## ADDENDUM #2

Reference: UDOT Region 3 Fire System Upgrades  
DFCM Project No. 05233900

**Subject:** Revisions to Fire Protection Drawings and Specifications for Addendum 2

FIRE ALARM  
SYSTEM PLAN  
ADMINISTRATION  
BUILDING LEVEL 1  
FP-3.1

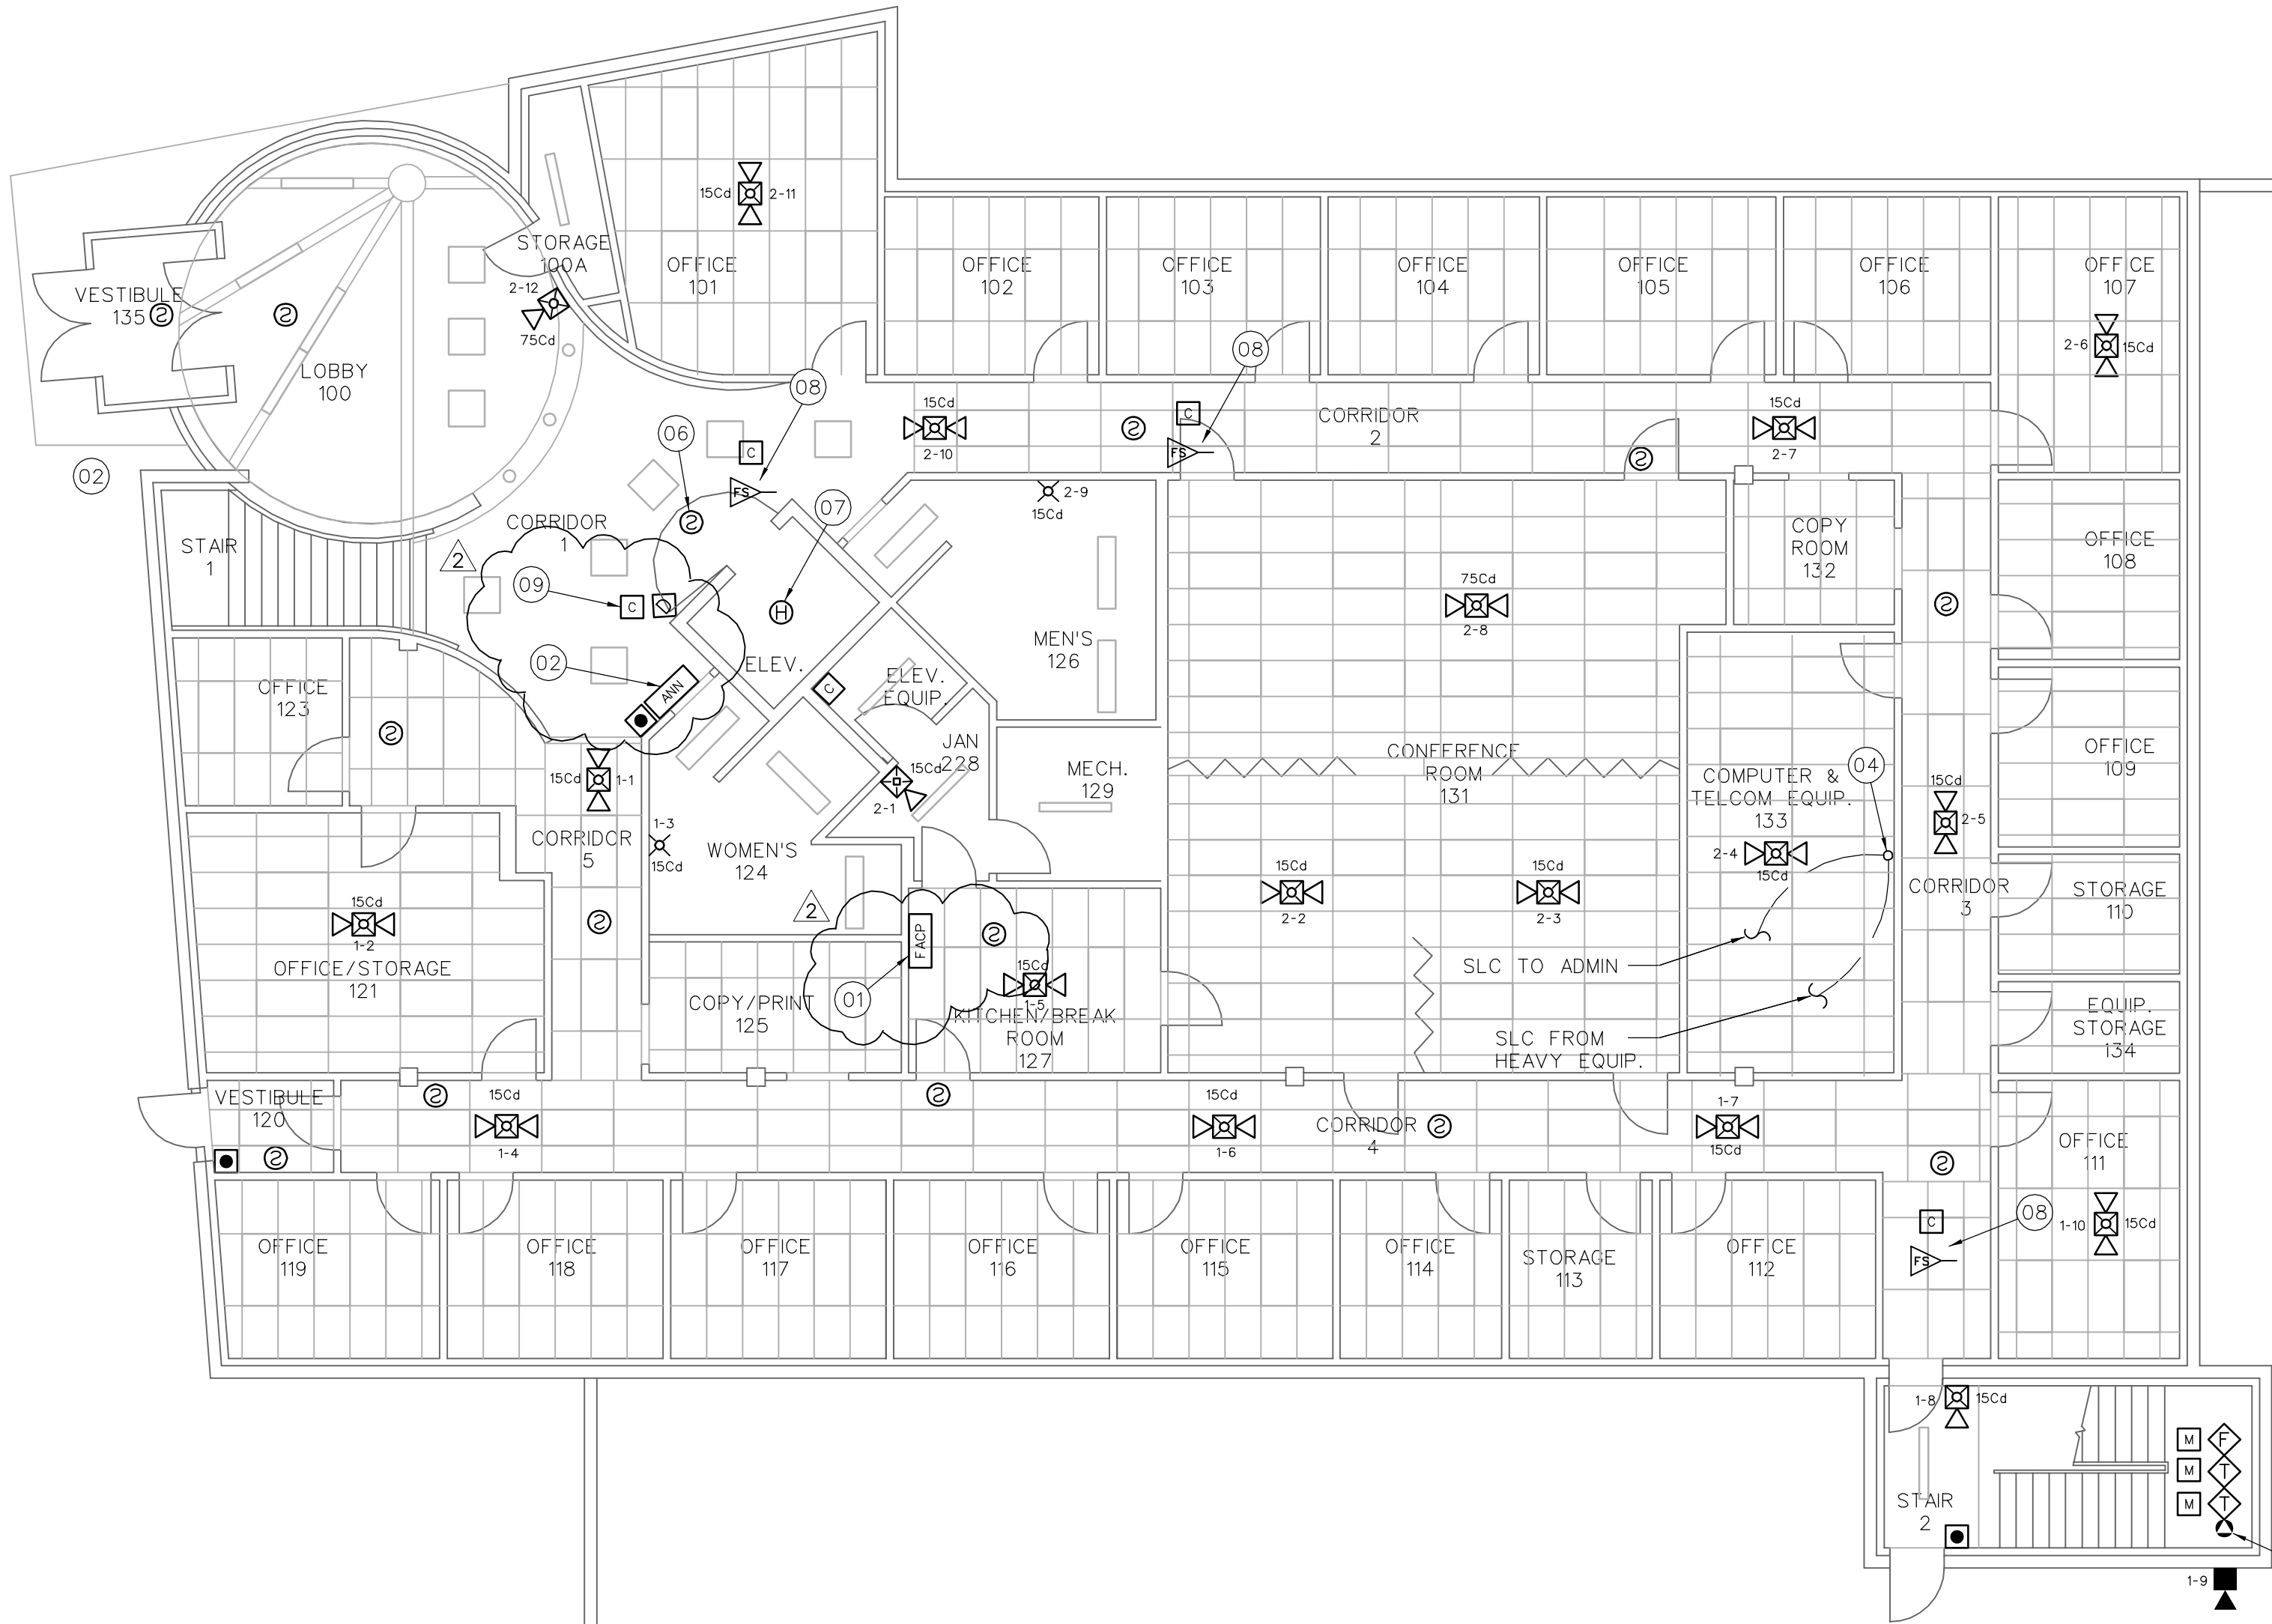
1. Relocated annunciator panel from glass wall at entry to sheet rock wall adjacent to elevator.
2. Indicated existing door hold-open device on door at elevator lobby and added key note 9 to specify connection of existing door hold-open device to new fire alarm system.
3. Relocated FACP to Kitchen/Break room and revised key note 1 to require FACP to be installed recessed into wall.
4. Relocated control modules, heat and smoke detectors for elevator recall from 2<sup>nd</sup> floor to elevator equipment room on 1<sup>st</sup> level.
5. Edited key note 4 to require waterproof cable in buried conduits between buildings.
6. Edited general note 7 to allow the use of flexible conduit and metallic clad (MC) cable.
7. Added general note 14 to require demolition/removal of existing system that provides elevator recall and actuation of fire/smoke dampers.
